**AGENDA
CITY OF CEDAR FALLS, IOWA
PLANNING AND ZONING COMMISSION MEETING
WEDNESDAY, JANUARY 23, 2019
5:30 PM AT CITY HALL**

TO: Planning and Zoning Commission
FROM: Iris Lehmann, Planner II
Matt Tolan, Civil Engineer II
DATE: January 17, 2019
SUBJECT: Greenhill Village Townhomes II – Preliminary Plat

TO: Planning and Zoning Commission
FROM: Iris Lehmann, Planner II
DATE: January 17, 2019
SUBJECT: Greenhill Village Townhomes II – Site plan

THE TERRACES AT WEST GLEN DEVELOPMENT CONCEPT

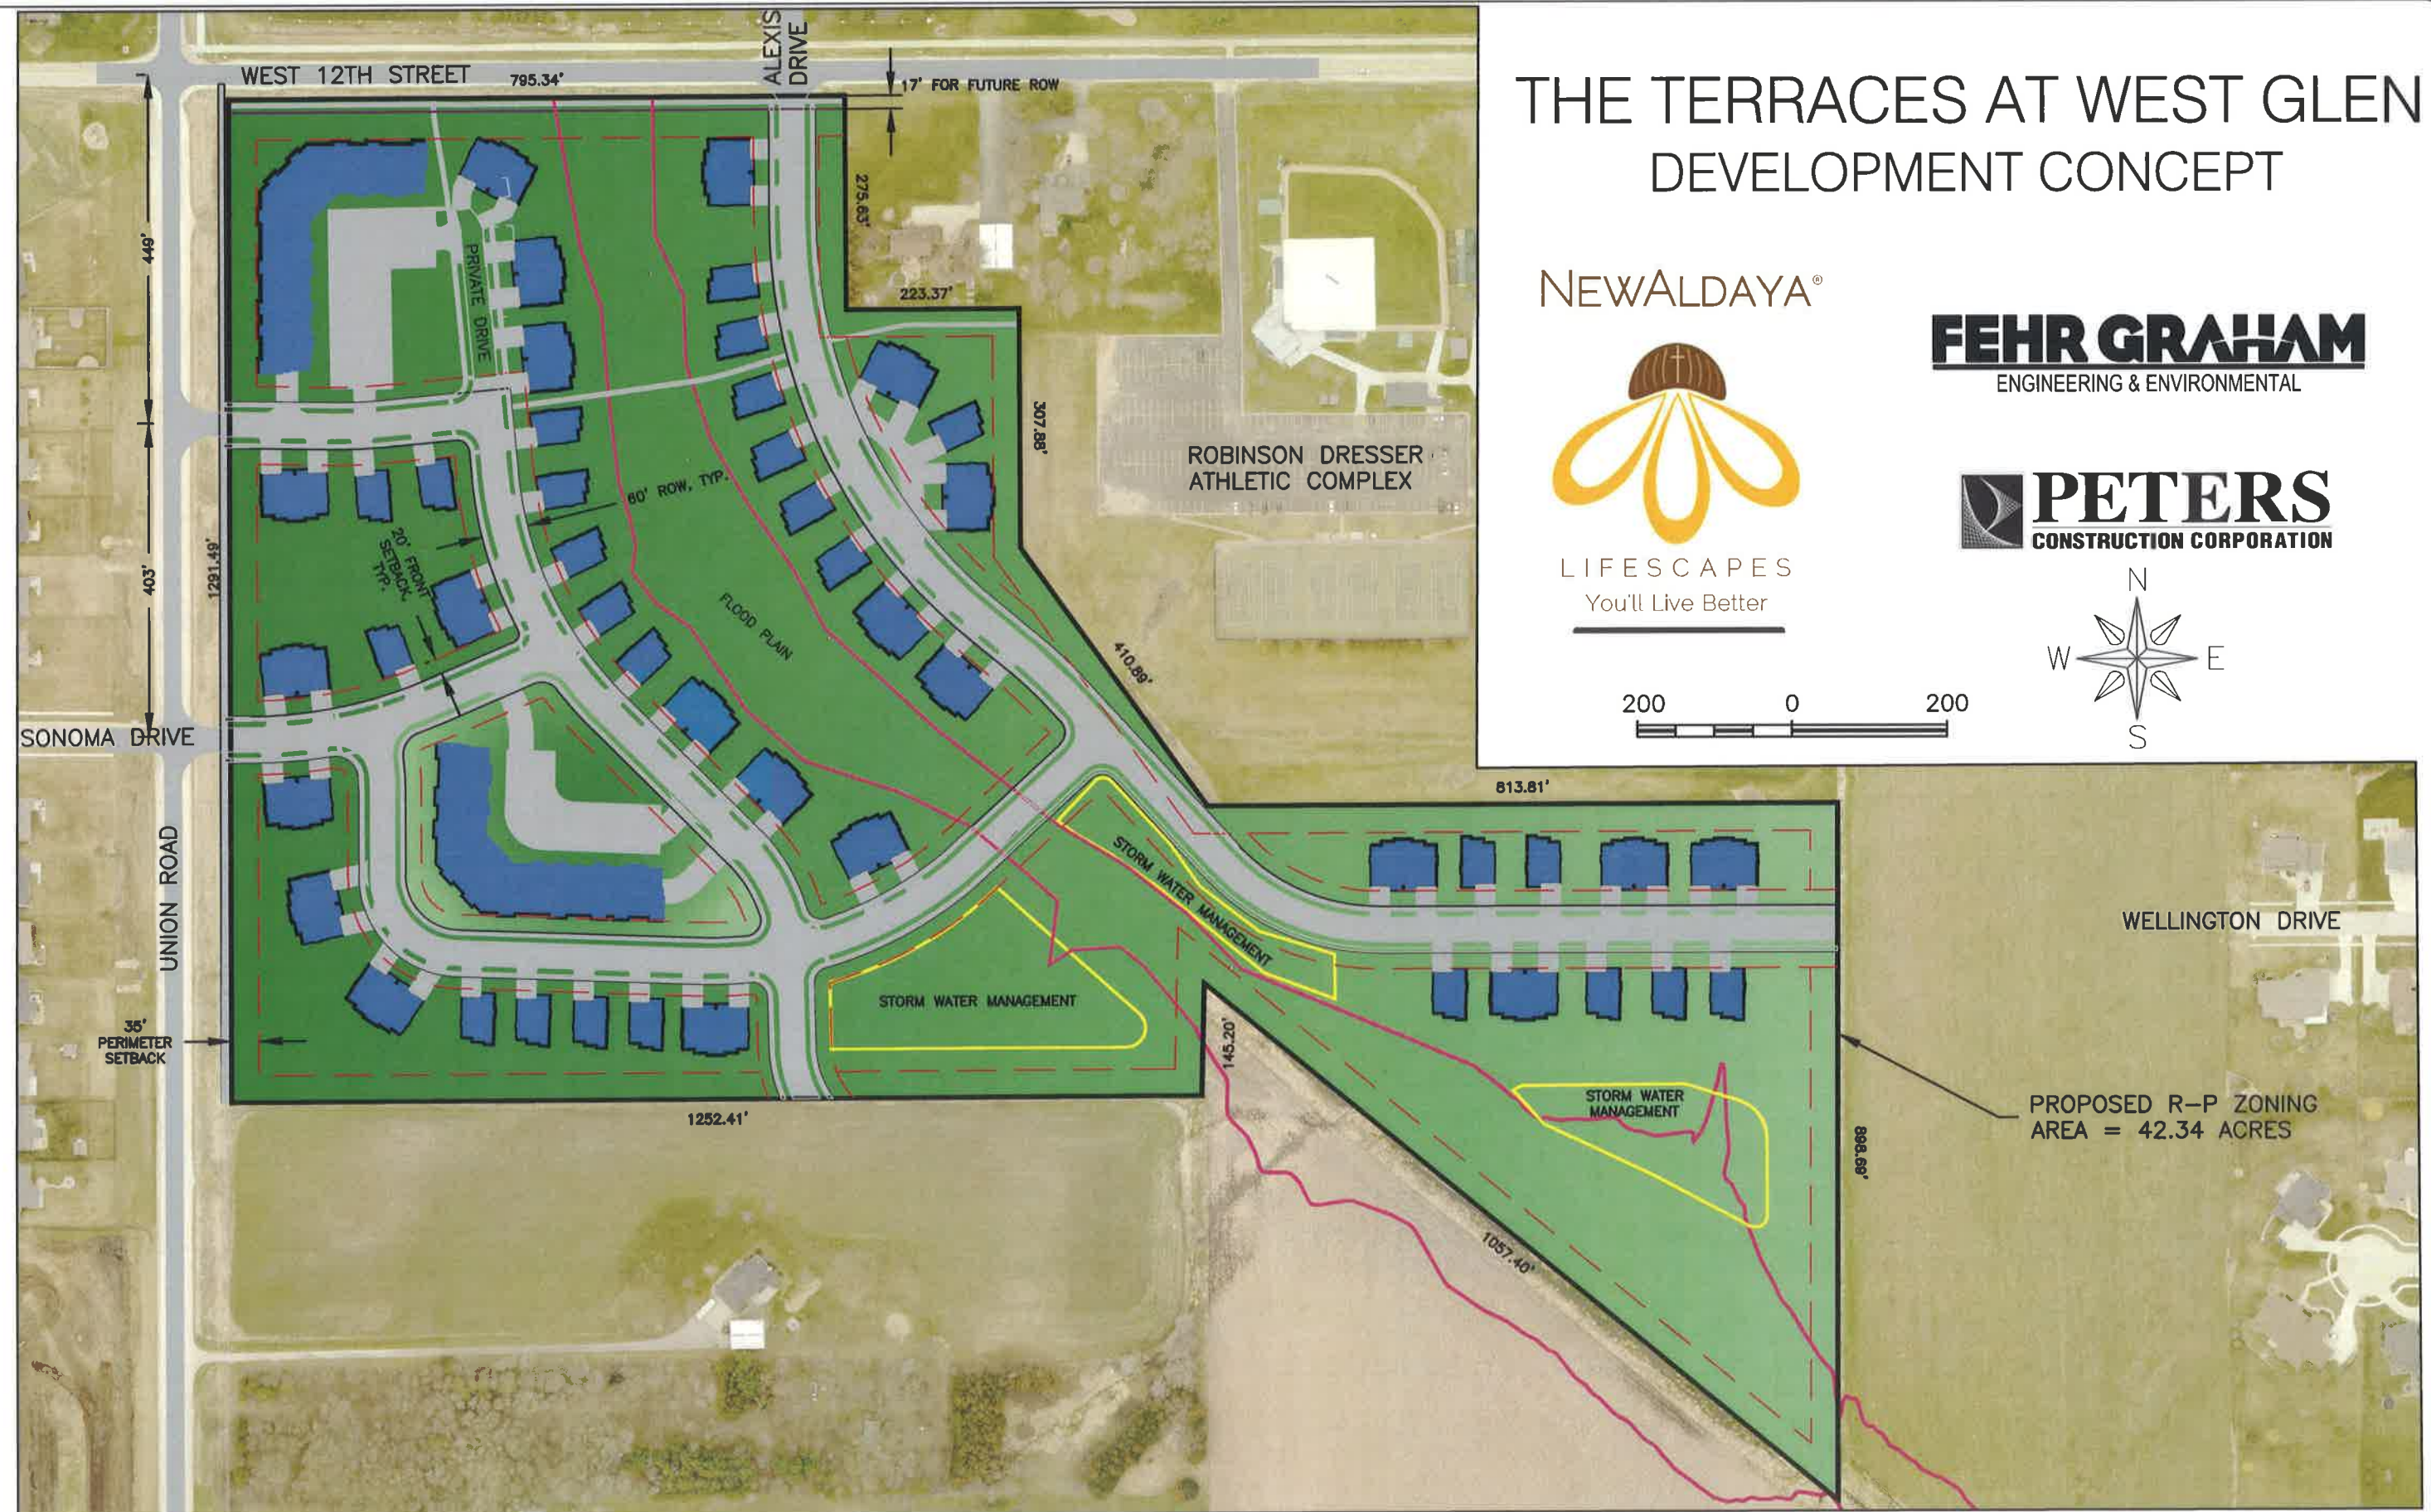
The property currently has access from W. 12th Street and Union Road. The development concept plan shows two public street connections onto Union Road and one public street connection onto W. 12th Street. The two street connections onto Union Road are approximately 449' and 852' feet, respectively, south of W. 12th Street. The southern street connection onto Union Road is directly across from Sonoma Drive. The W. 12th Street connection is approximately 750' feet east of Union Road and it is directly across from Alexis Boulevard. The development concept plan also shows a street stub to the south and a street stub to the east. These street connections will be important for general traffic circulation and connections between neighborhoods and future neighborhoods. For example, while there may be no development planned for the existing large single family properties to the south, at some point in the future there may be a desire to further subdivide those lots. Without a street planned street connection to this area, future infill development would not be possible. Staff notes that during the preliminary platting of the subject property, care should be taken to locate these street connections so they can be extended in a logical manner to adjacent properties and avoid conflicting with existing development. For example, the street connection to the south should be located to avoid extending too close to the existing home to the south. Angling this future roadway to the east to potentially parallel the creek may be an appropriate option.

PRELIMINARY PLAT

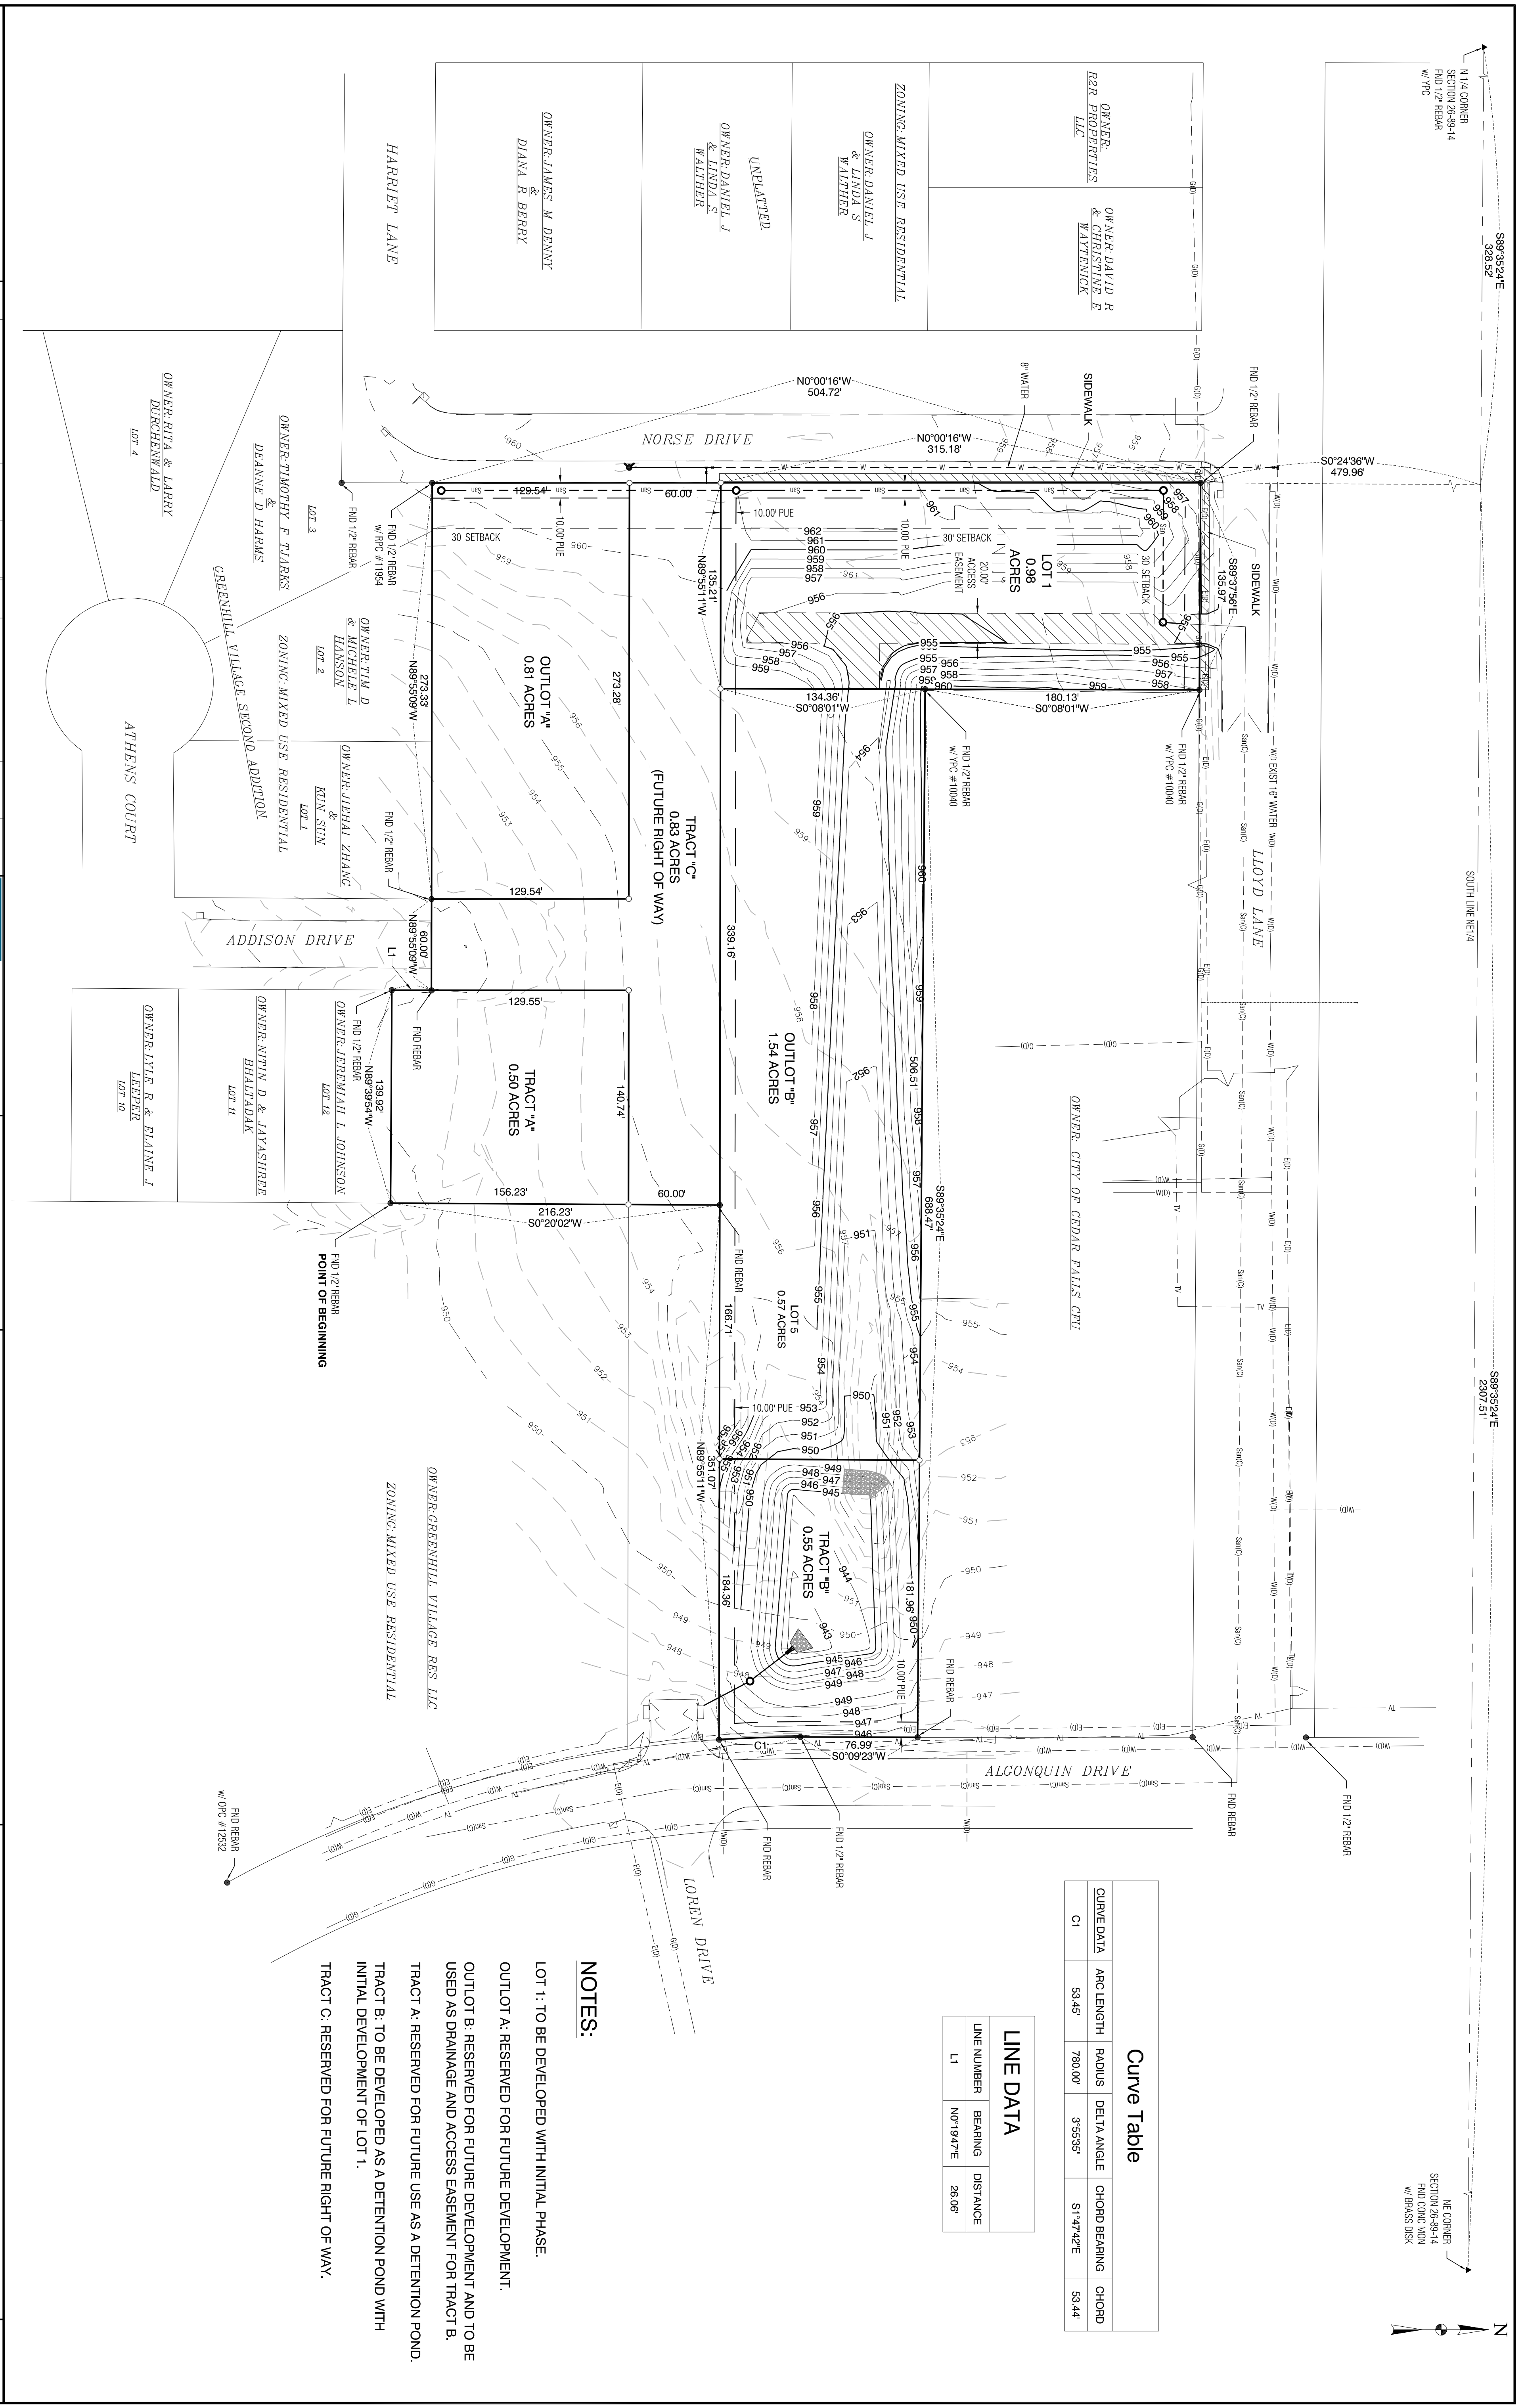
3. Add a public sidewalk on the east side of Tract "B".
4. A note about wetlands should be shown.
5. A utility easement needs to be shown of the North line of Lot 1 for the sanitary sewer.

7. The boundary line of the addition needs to be a heavier line weight than the interior lot lines
8. On Sheet 2 of 2 remove "Lot 5 0.57 acres" language from the Plat

9. Deed of Dedication – will be finalized with the Final Plat
10. Submit final stormwater management report at time of construction plans.
